# As-built Baseline Monitoring Report FINAL

## Blair Creek Mitigation Project

**Subject:** Response to DMS Comments (dated 5/9/22) for Draft As-Built Baseline Monitoring Report  
Blair Creek Mitigation Project, Clay County  
Hiwassee River Basin: 06020002  
DMS Project #100047, DEQ Contract #7415

Table 2:

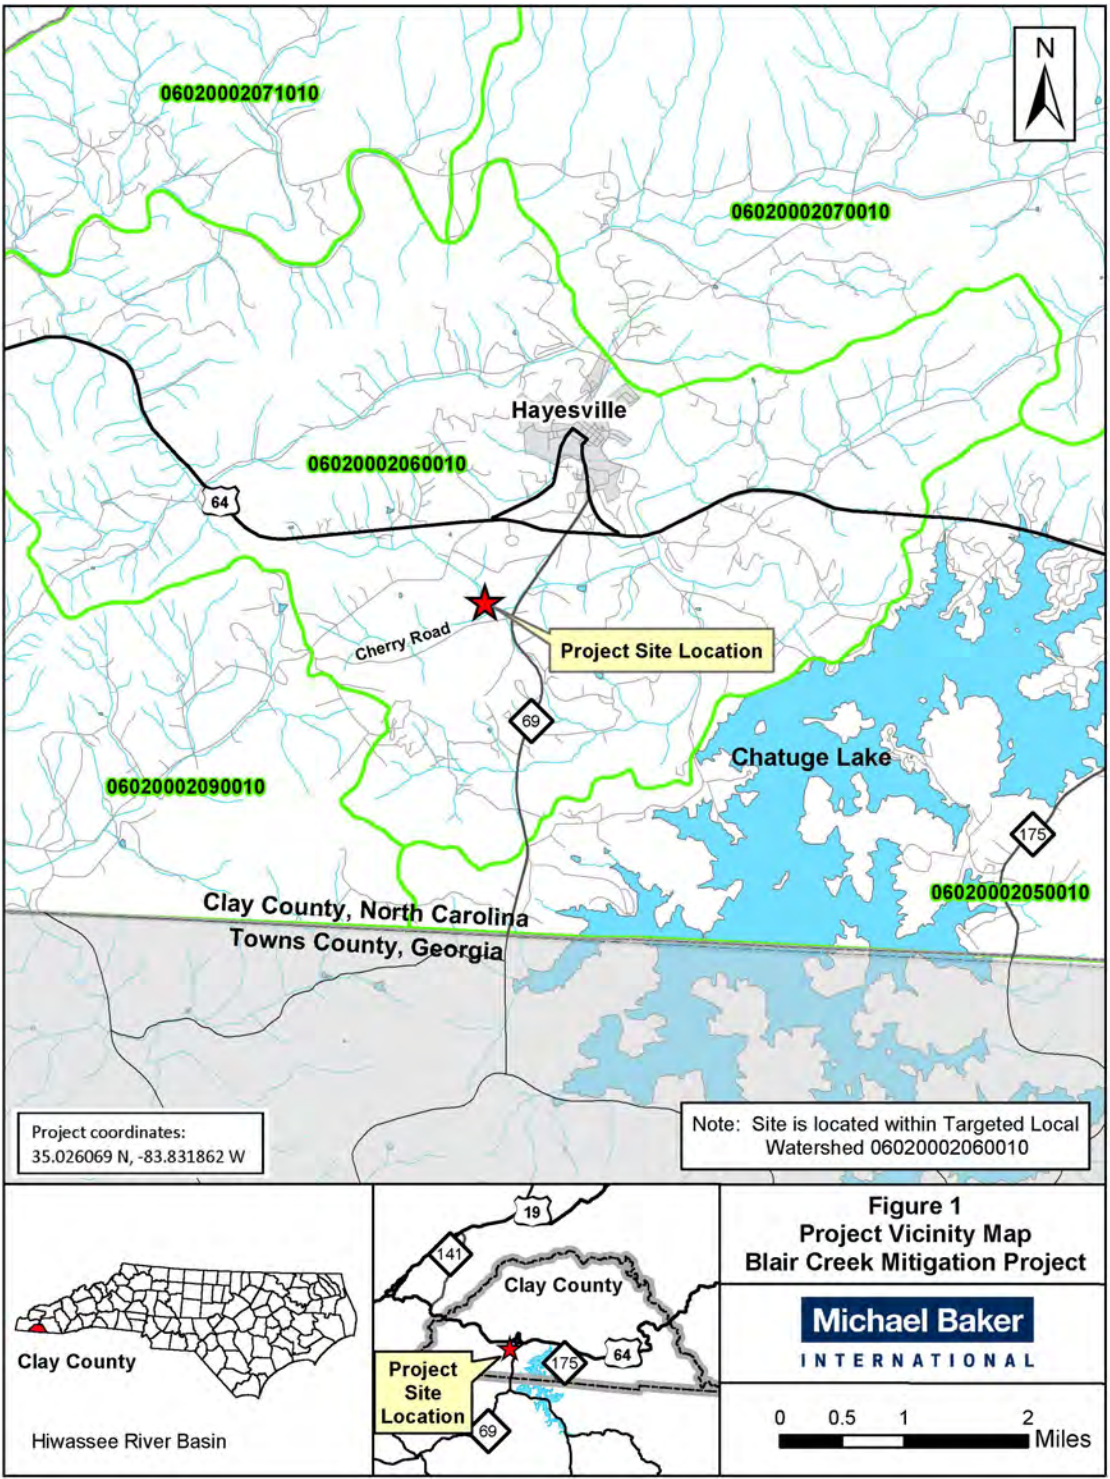
- Remove 404 permit date line.
- Add “Project Instituted Jan-18” as the first entry in the table.
- Please add two lines below As-Built Baseline Monitoring Report (MY0) entry: “Vegetation Monitoring” and “Stream Survey” and the dates that these activities were completed. Please include this information for future monitoring reports.  
**Response: Table 2 was revised as requested.**

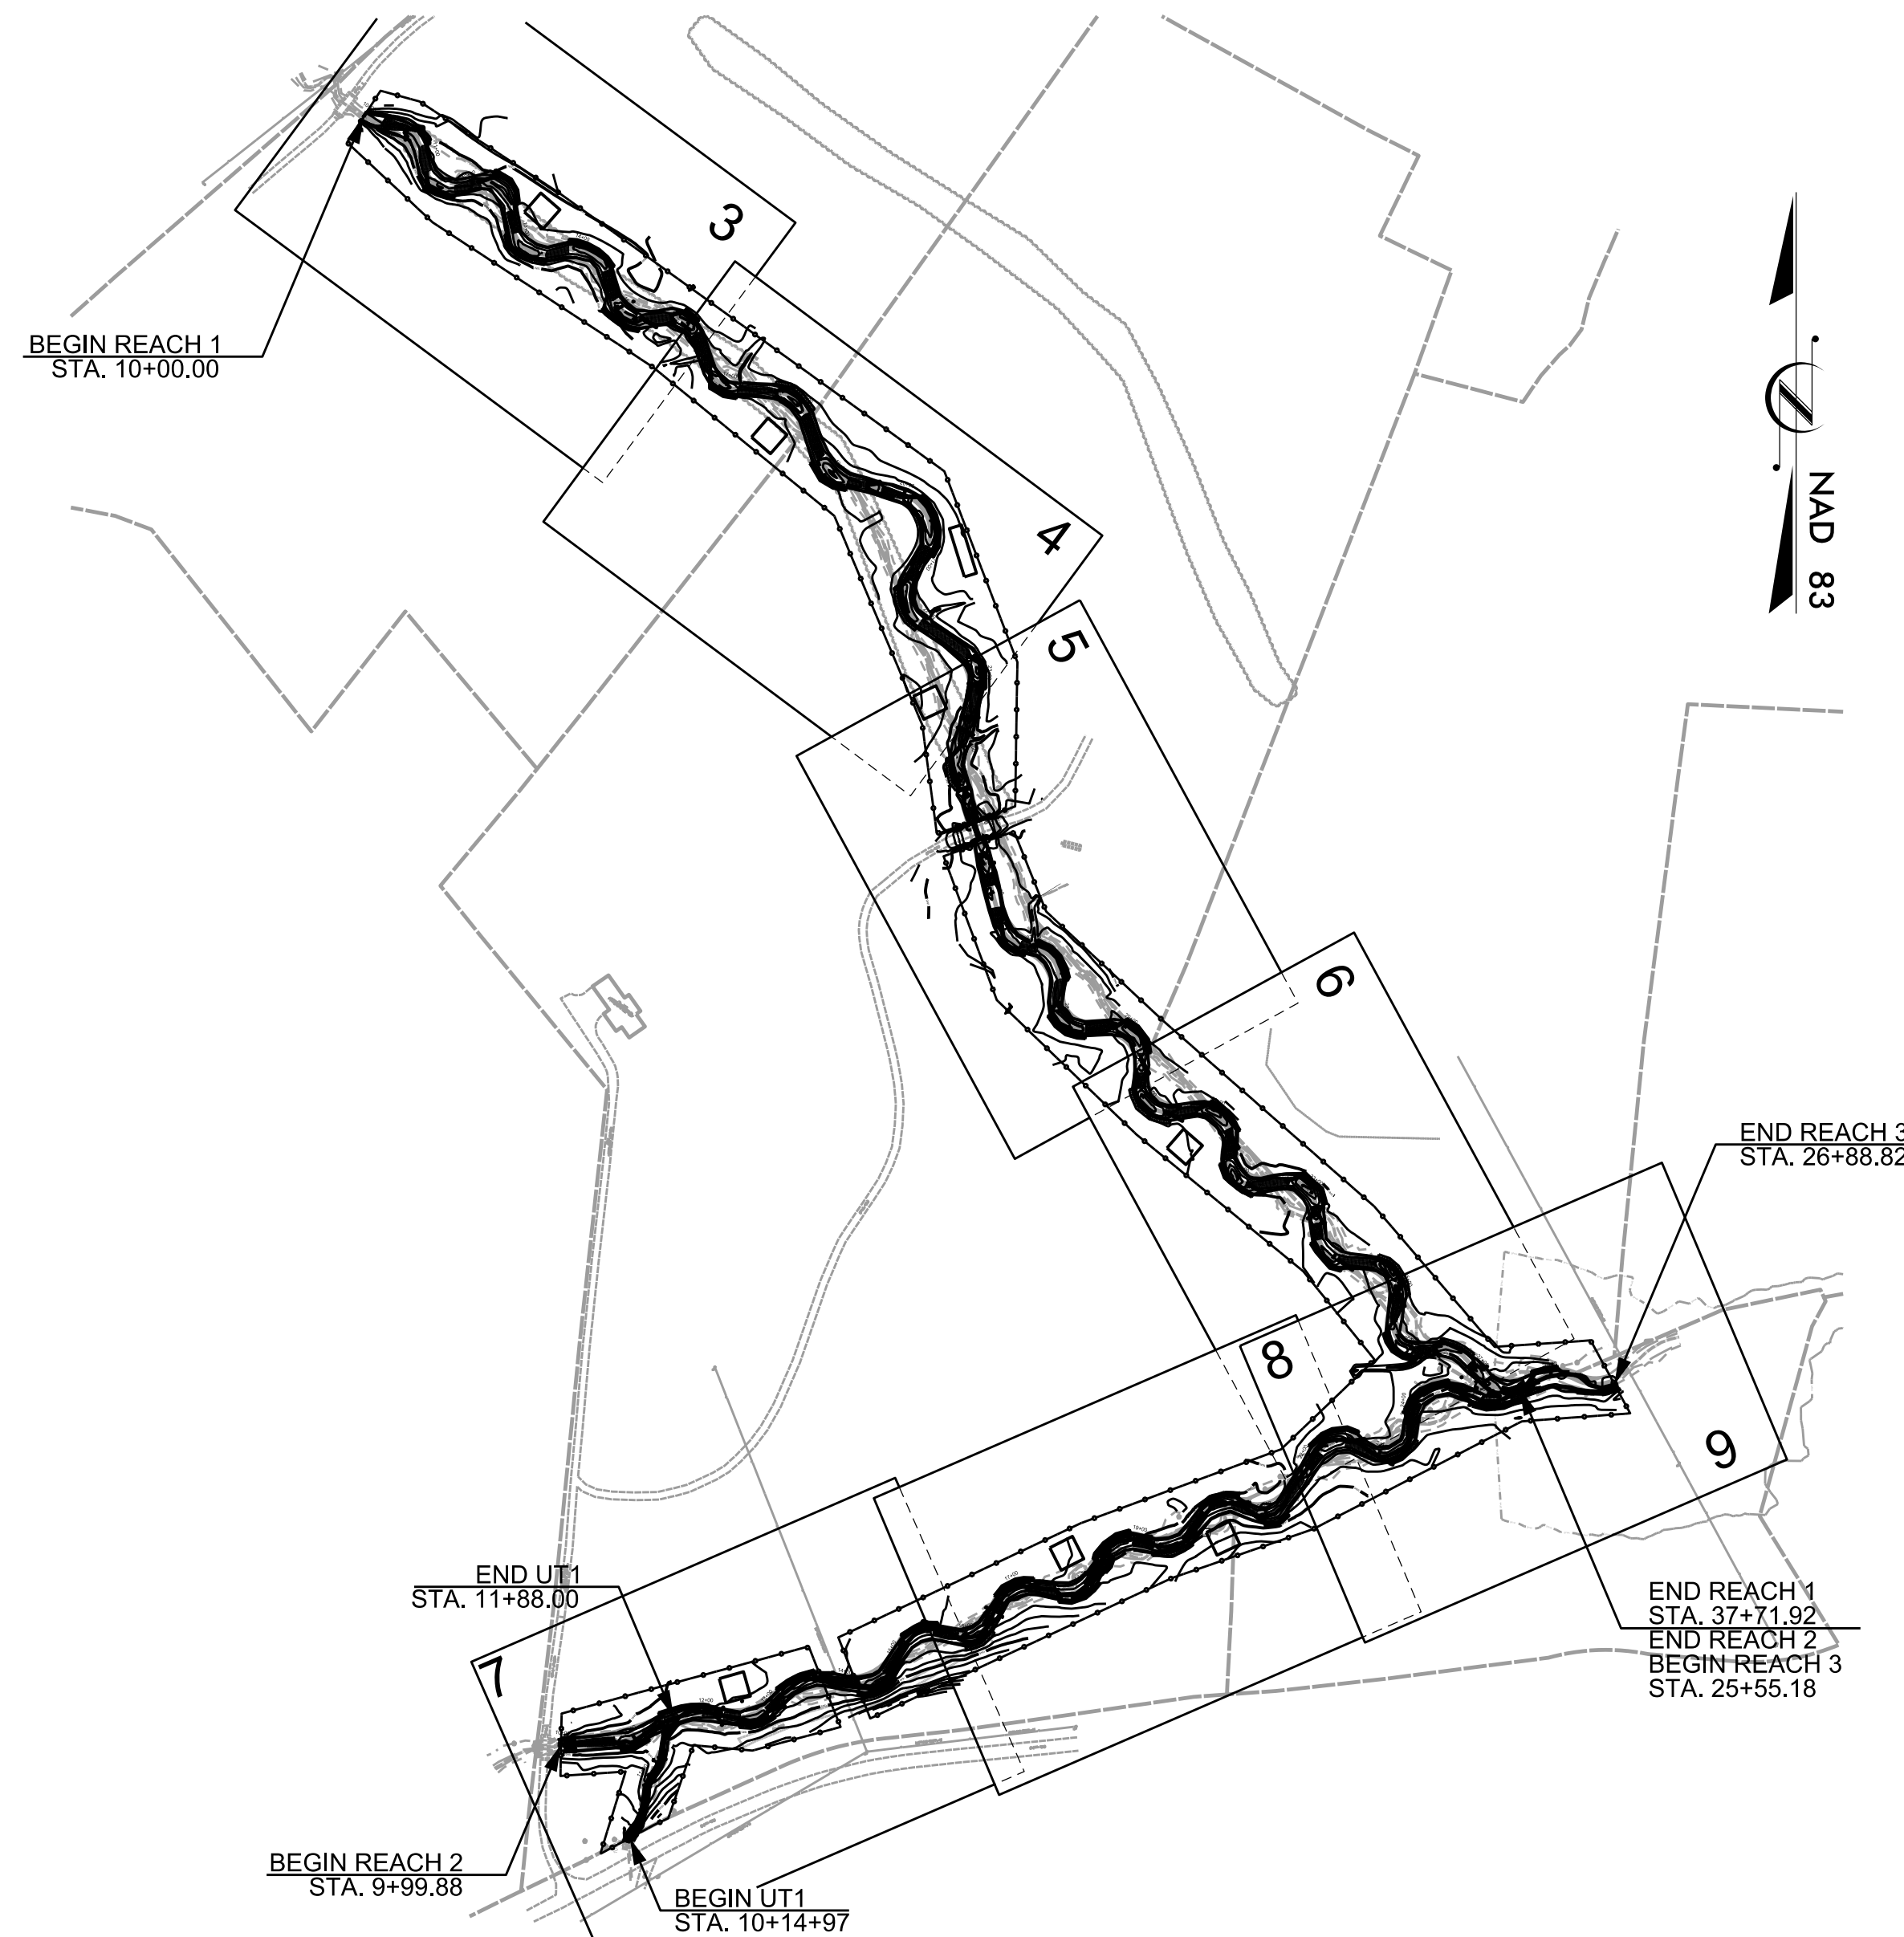
- The four oaks (*lyrata*, *phellos*, *pagoda*, *michauxii*) listed in the section as planted but not approved in the Mitigation Plan and therefore not counted to determine planted densities. These species were included on Sheet 1-A of the approved Mitigation Plan. Please review and make corrections as necessary. Table 5, CCPV call outs and report will need to be updated if vegetation stem/ac totals change.

**Response: Those four oaks were not actually approved in the final, revised Mitigation Plan planted species table, though they had been incorrectly shown on the construction plan sheet species table (as explained above). Thus, they were not considered as counting towards vegetative success. Table 5, the CCPV, and all numbers and references to vegetation in the report only include those species that were accepted in the final revised list of approved species from the Mitigation Plan. Notably, despite the loss of several planted species allowed to count towards success, all veg plots on site have high planted densities and are expected to perform well throughout the monitoring period.**
